Staff Report & Recommendation

Historic Preservation Board

SUBJECT: HPB20-0389 a.k.a. HPB 7490, **3425 Collins Avenue.**

The applicant has submitted plans entitled "Aman Hotel & Residences", as prepared by Revuelta Architecture International, dated November 10, 2020.

1955 west elevation drawing of the porte-cochere, Permit No. 47326

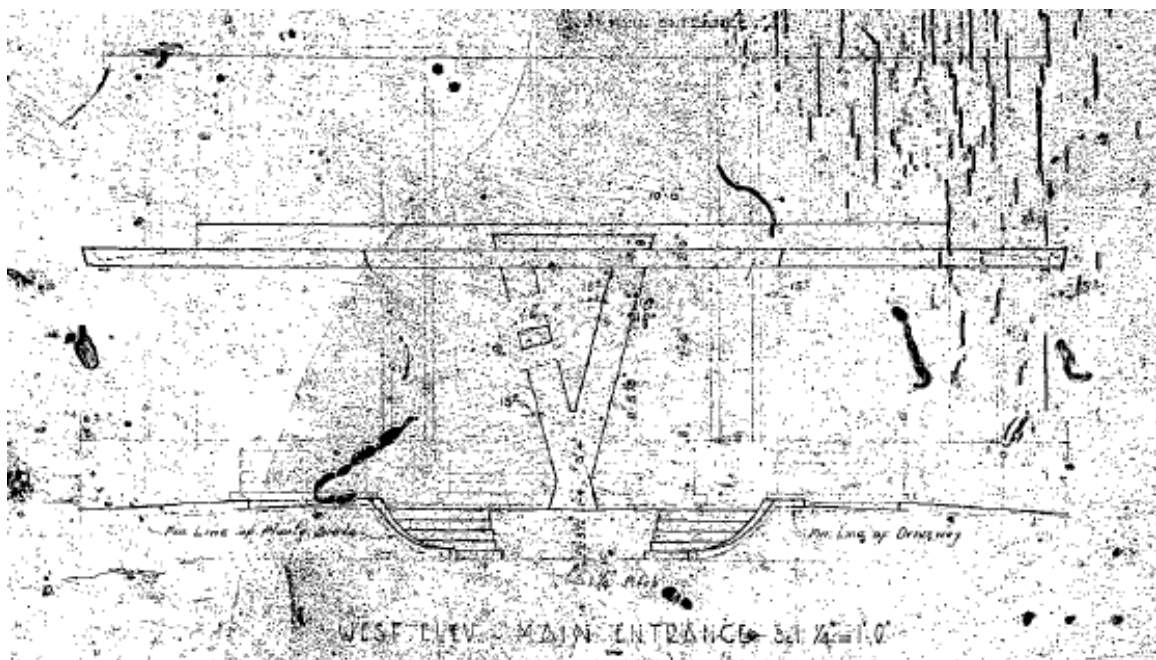
- **Porte-cochere reconstruction.** The applicant is currently proposing to reconstruct the previously existing Post War Modern style porte-cochere substantially consistent with available historical documentation including the V-shaped pylon. Staff would note that the porte-cochere was introduced in 1955 as part of renovations to the site which included construction of an attached 132-room south addition. Both the addition and porte-cochere were demolished in 2016 as part of the previously approved project. It is important to note that in order to accommodate emergency vehicles, the applicant is proposing to reconstruct the canopy at a slightly higher height. Staff is highly supportive of the proposed reintroduction of this highly significant architectural feature.

- b. The design of the porte cochere shall be consistent with the plans entitled "Aman Hotel & Residences", as prepared by Revuelta Architecture International, dated November 10, 2020. Final details and materials of the porte-cochere on the west side of the Versailles building shall be submitted, in a manner to be reviewed and approved by staff consistent with the Certificate of Appropriateness Criteria and/or the directions from the Board. All lighting and any required sprinkler systems shall be completely recessed into the structure. The plans for porte-cochere/entry canopy on the west side of the Versailles building, as shown in the plans dated February 10, 2020, shall be further developed and shall require the review and approval of the Board, prior to the issuance of a Building Permit or a revision to any active Building Permit that includes a porte-cochere/entry canopy.
